Land north of Wychurch Farm, Malmesbury: Transport Statement Addendum

Ref: MS/SGe/ITS200270-004B
Date: 18 February 2026

- 1.1 This Note presents an updated site layout related to an outline planning application for up to 149 homes on land north of Whychurch Farm, Malmesbury (*planning application ref: PL/2025/02257*).
- 1.2 The layout addresses the comments of Wiltshire Council (WC) Highways, dated 15th April 2025 and Wiltshire Rights of Way, dated 15th April 2025 on an earlier scheme layout presented in a Transport Assessment (*i-Transport Report Ref: ITS200270-007A*) dated 27th February 2025.
- 1.3 The site layout is provided as **Appendix A** and extracted below in **Image 1.1**.

Image 2.1: Access Arrangement

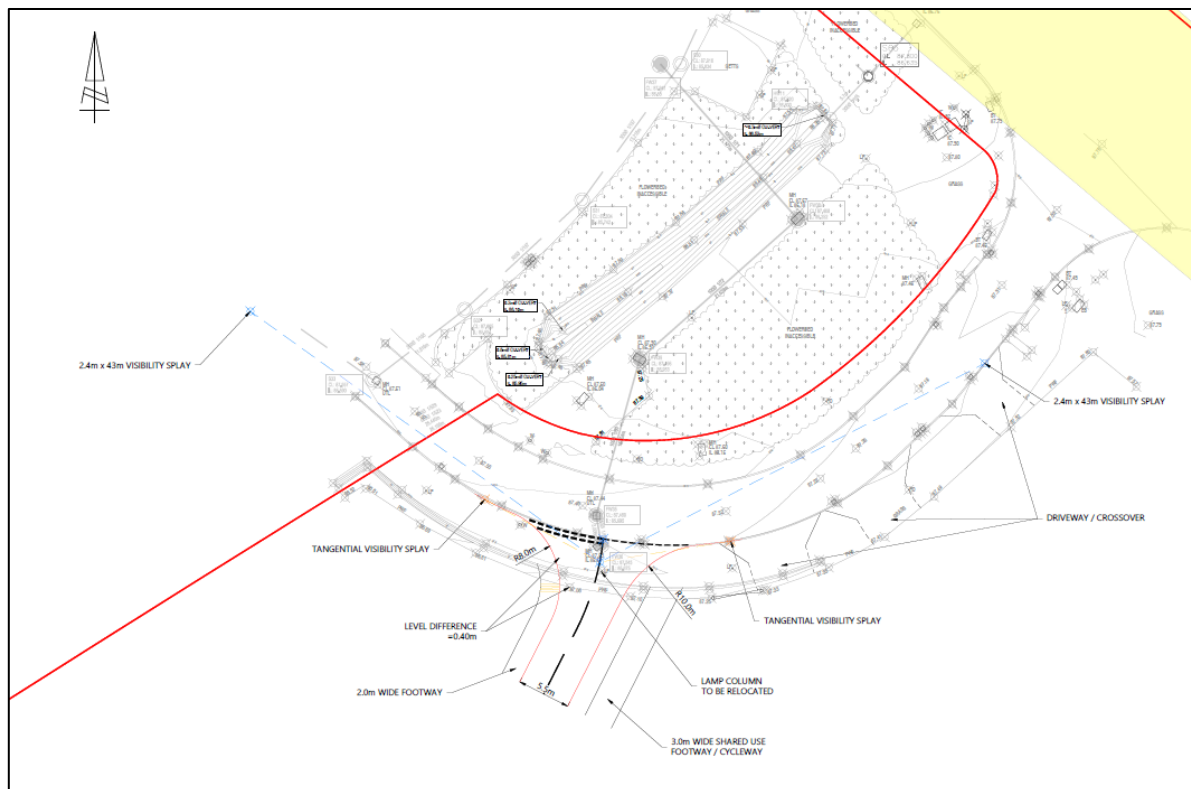
While the access location has been previously permitted in an earlier outline application and currently subject to a reserved matters application, the level details require further detail to be indicated.	It is agreed that matters related to levels at the access can be addressed through a reserved matters application. The level differences do not present insurmountable issues.
Due to the location of the site, there will be limited potential for connectivity to primary or secondary school and these journeys will by necessity involve private car journeys at drop off and pick up times. There is potential for cycle routes to be used for older children, but an additional contribution may be sought to aid the provision of school busing to the proposal site. For details of amounts I am happy to discuss further with the Public Transport Team if you require that at this stage. Future design of the site must be able to demonstrate adequate access and turning for bus provision.	It is agreed that no public transport contribution will be sought. No provision is needed for bus access.

While the access location has been previously permitted in an earlier outline application and currently subject to a reserved matters application, the level details require further detail to be indicated. The access road from the B4014 has been built out and the proposed access road for this application above will need to be brought up to the level of the built road whilst not compromising the built retaining structure. There is no information on the mechanism for bringing the main estate road up to level or how the private accesses along the shared access road will be achieved. While technical information to engineering challenges can be provided within a further Reserved Matters Application or eventually a Section 38 agreement package, due to the level differences I would like some assurances that this has been taken into account by the applicant and that information can be brought forward to provide clarity within the planning process.

- 2.1 The proposal continues to be an outline application for up to 149 homes.
- 2.2 The access to the adjacent Bloor's site has now been built. Therefore, the access to the application site has been updated using topographic mapping of the completed access. This is presented as drawing **ITS200270-GA-005A** provided to the rear of this report and extracted below. The drawing shows a 2m footway on the western side of the proposed access and a 3m shared footway / cycleway on the eastern side of the access, noting that there is a shared cycleway on the southern side of the Bloor access road. This is in accordance with the comments of WC, set out in Section 3.

Project	Land north of Whychurch Farm and west of Crudwell Road		
Drawing	Illustrative Masterplan		
Client	Gleeson Strategic Land		
Job no.	GLEE240917	Date	31.01.25
Dwg no.	IMP.02	Rev.	E
Author	NJ/TM	Checked	NJ
Status	PLANNING	Scale	1:1250@A2
		Office	Portishead
Client ref.

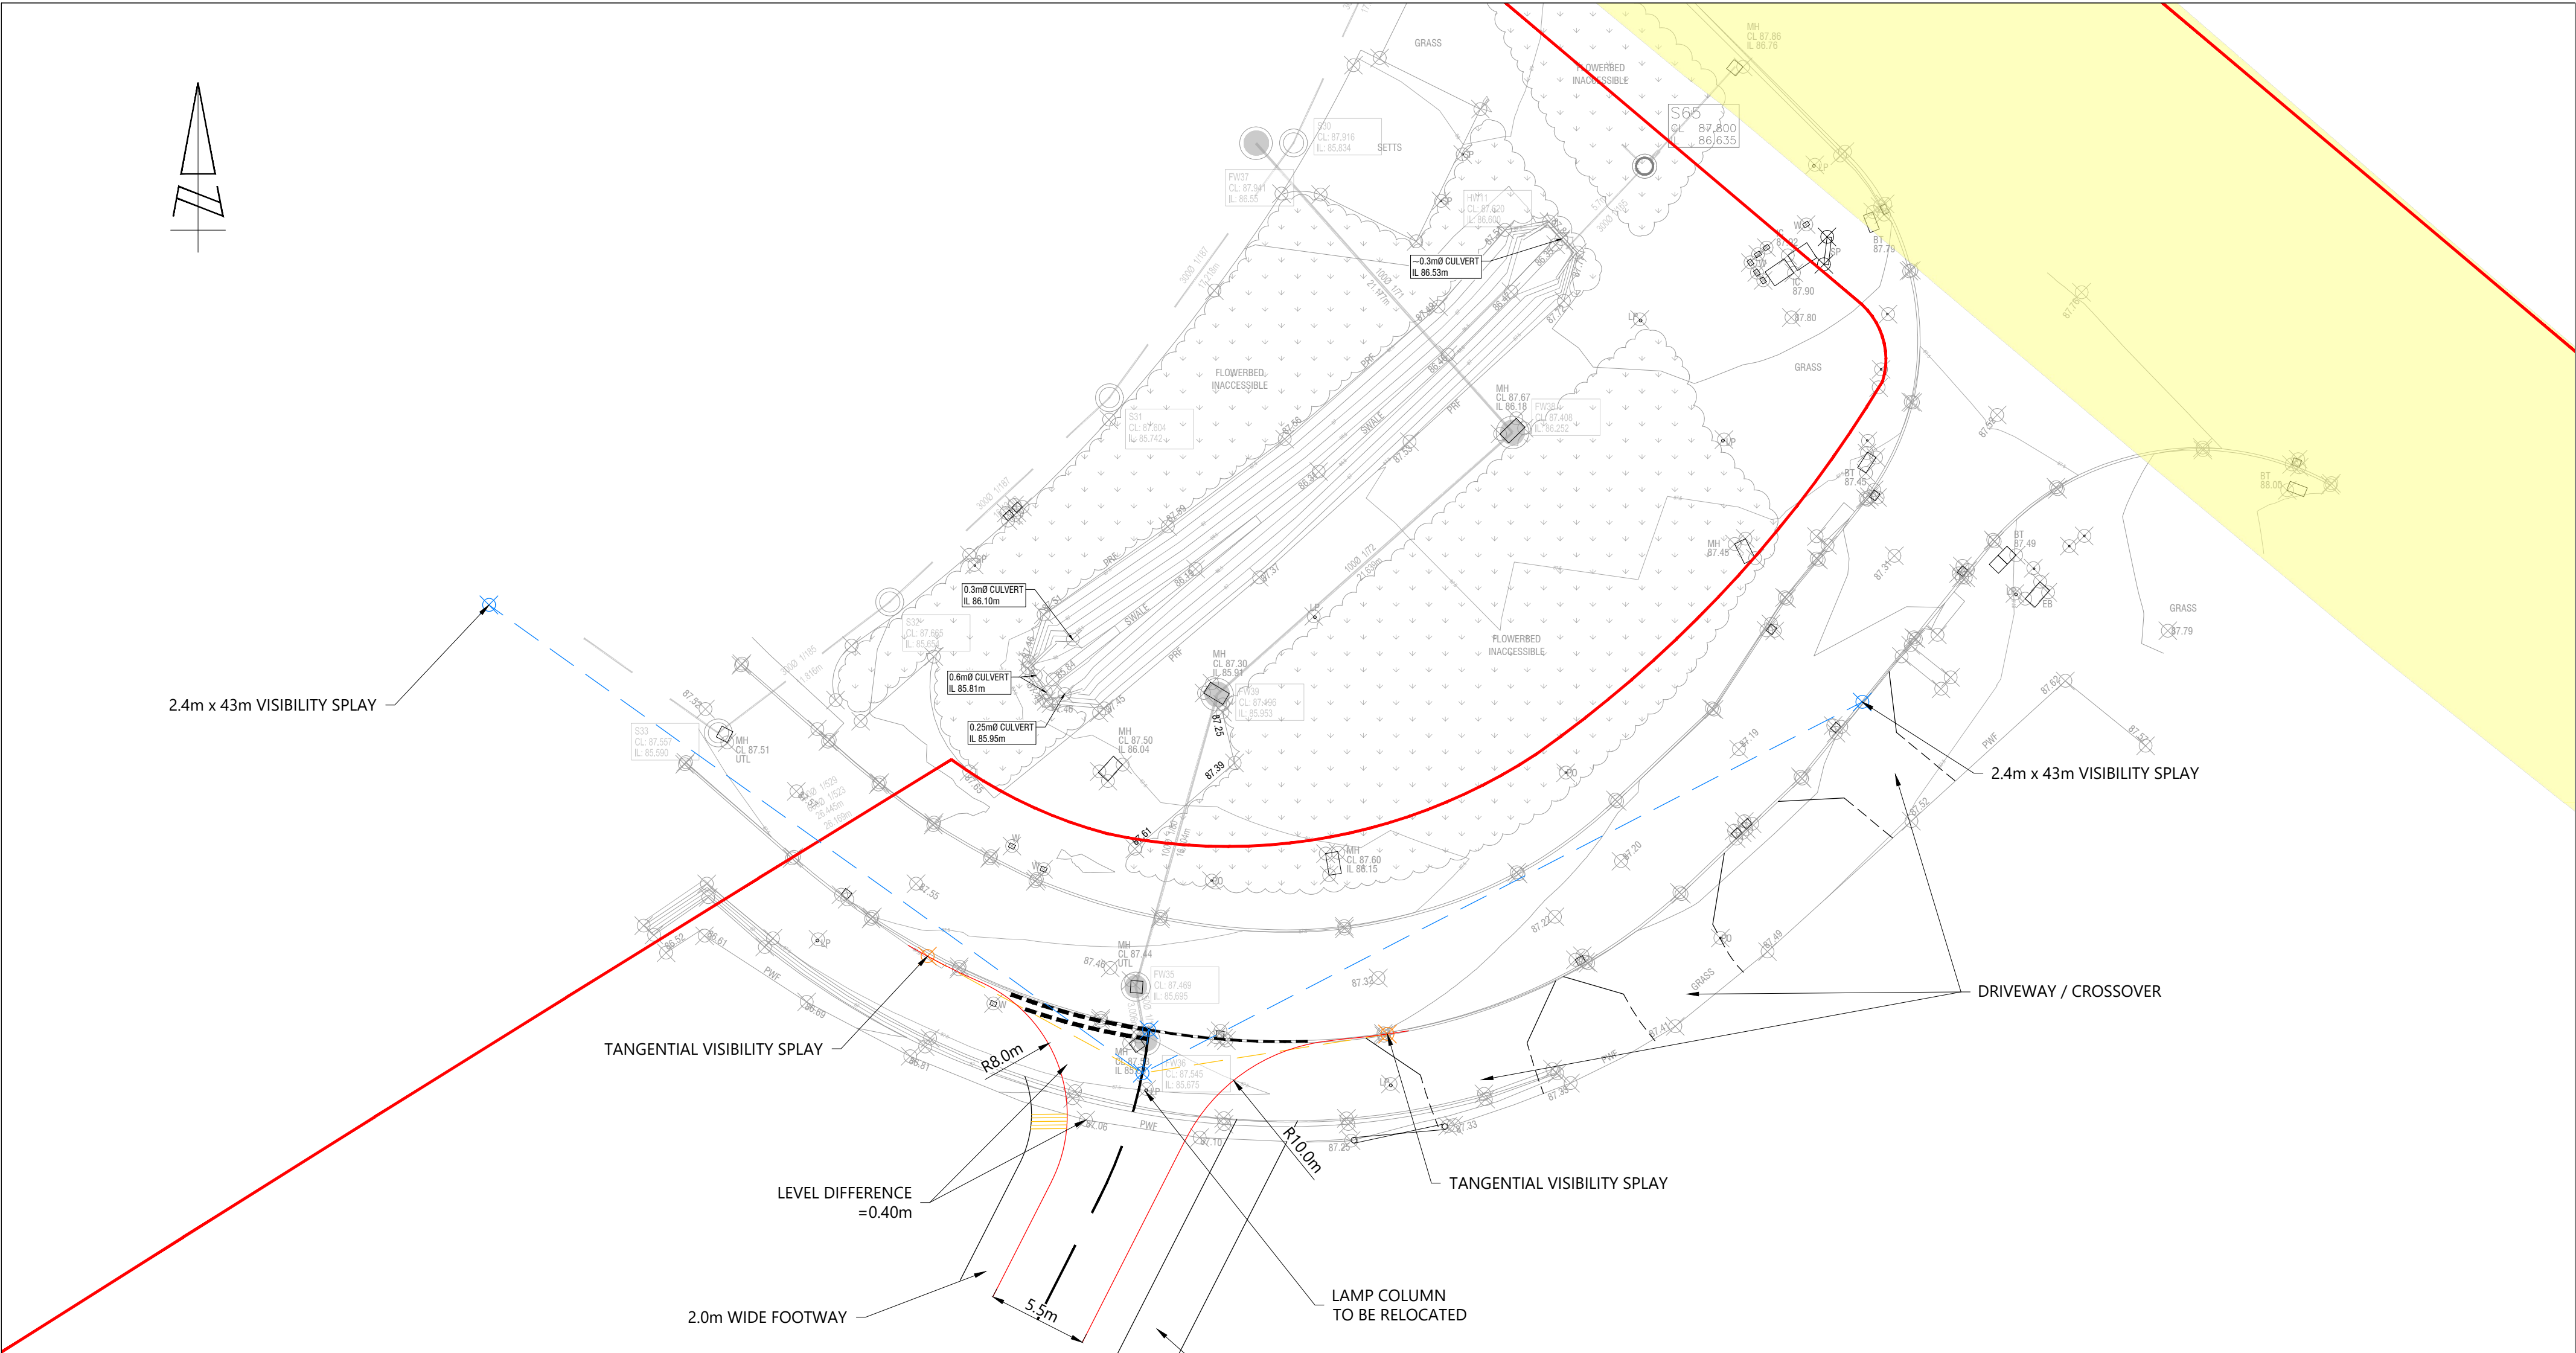
Comment	Response / Action
The PROW named MALM8 is subject to an order of diversion and will border the western fringe of the proposal site. Connection via footway or footpath is expected to the north of the proposal site and should be achieved at the south of the proposal site toward Lacemakers Road. A POS path connecting from the planned designed path west across the POS to the boundary of the application site at Lacemakers Road will allow for this connection to be achieved. A path to the west of the POS to the south of the site can also form a connection to Ron Golding Close. Improvements to the north south public open space track off-site could be funded with a contribution provided through this application. Informal contact regarding connection has been made and there is an agreement that this site has the provision of providing the connection to the SUP MALM8 at two points to the west of the site. This will allow a connection across the drainage ditch bordering the site to the west.	This is agreed and the following accesses are shown on the masterplan at Appendix A. For ease, these are summarised below: 1 A 3m wide path to connect to the MALM8 path to the west of the proposed site, where the play area has been located. 2 A 3m shared use connection to MALM8 / Lacemakers Road from the public open space to the rear of plot 59. 3 A 2m pedestrian connection to Ron Golding Close.

Comment	Response / Action
Both routes of MALM7 should be constructed to adoptable standard and included within the section 38 adoption or as 278 works whichever the Wiltshire Council Highways Officers feel is the most appropriate route. The applicant seems to be aware from how they have designed the development that some of the Public Rights of Way access furniture is not positioned on the definitive line. The kissing gate on the West side of the site is located approximately 17m to far to the North and the constructed path of MALM7 should follow the route shown on the masterplan and a new gap in the hedge should be created. I don't believe that any access furniture is required at this location as no stock is grazed in the field to the West. The Southern spur of MALM7 where it meets the A429 is currently obstructed by a barbed wire fence. A gap will need to be created here and if it is felt that a bollard or barrier is required here for public safety then the applicant will need to apply to the Countryside Access Officers for the authorisation of a structure.	This is agreed. The field boundary fence and kissing gate will be removed and MALM7 is provided on the existing alignment of its southern fork. To enhance pedestrian connectivity, a further pedestrian / cycle access to the A429 will be provided to the north, and this will form part of a wider north-south spine route through the estate. This is illustrated on the masterplan (Appendix A).

The development to the west has built a 3 m width shared use path connecting from Filands Road, B4014 to the proposed access for the above numbered development. Within the access detail and the masterplan there is a 2 m wide footway running from north to south, this will need to be upgraded to a 3 m wide SUP to connect non-vehicular use from the B4014 to the line of the Right of Way MALM7 and then to the Whychurch Roundabout to make an eastern connection to the site.

Rev	Description	Date	Au	Ch
A	Issued for planning	24.02.25	NJ/TM	NJ
B	Boundary updated	04.03.25	LC	NJ
C	Layout updated	20.11.25	LC	TM
D	Addition of 3m shared cycleway through site	16.01.26	TM	RP
E	Addition of acoustic fence to eastern boundary	28.01.26	TM	RP

Landscape MA			
Status:		Drawn by:	Checked by:
For Submission		LB	TF
Project Number:	Scale @ A1:	Date:	
227612	1:750	21/09/2023	
Drawing Number:	Revision:		
TOR-XX-XX-DR-L-P-(92)001	L

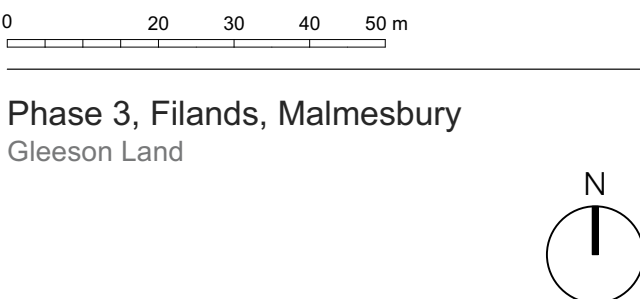
As part of the connections the developer must note on drawings that a hole will be provided in the boundary treatment, even if future path connection is not yet established to ensure that the Council is not left with the responsibility to make the connection. This should be established to the east by improvement of a 3 m width lighted SUP following the legal path of MALM7 to A429 and to MALM6 to the south. To ensure that future residents have a desirable local walking and cycling connections a S106 contribution of £100,000 would be sought to provide all suitable off-site connections.

To the west, (the site previously permitted at outline stage) a connection should be secured to link with the proposed west/east connection (3m shared use lighted path) and MALM8.	This is agreed and is dealt with in the point above i.e., a 3m wide path will be provided to connect to the MALM8 path to the west of the proposed site, where the play area has been located and a 3m shared use connection will be provided to MALM8 / Lacemakers Road from the public open space to the rear of plot 59.
Connection at the south of the site via 2m path to link to the current 2m path at Ron Goulding Close.	This is agreed and as previously mentioned, a 2m pedestrian connection to Ron Golding Close will be provided with a gap in the fence provided at the site boundary.
As part of the connections the developer must note on drawings that a hole will be provided in the boundary treatment, even if future path connection is not yet established to ensure that the Council is not left with the responsibility to make the connection.	This is agreed and, as above, a hole will be provided in the boundary treatment, and this is illustrated on the Landscape Masterplan (Appendix D).
